SERVICE BULLETIN

TS-430S NOISE BLANKER IMPROVEMENTS

10-17-84

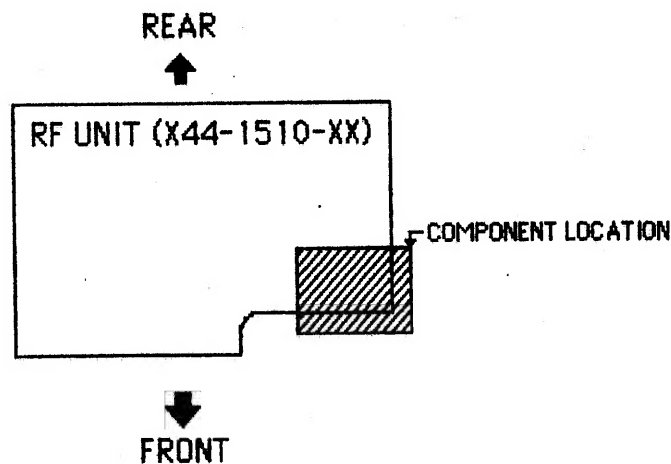
Some operators have indicated a desire to have their TS-430S noise blanker operate similar to the noise blankers in the TS-120S/130S series. By performing the following modifications the operator will be able to increase the effectiveness of the TS-430S Noise Blanker Circuit.

On the RF UNIT (X44-1510-XX) change the following components.

R80 change to a 100KΩ 1/4 watt resistor (RD14CB2E104J)

R81 change to a 56KΩ 1/4 watt resistor (RD14CB2E563J)

C125 change to a 560pF 25 v disc capacitor (CK45B1H561K)

This is an optional change and may not be performed in Warranty.
No realignment is required.
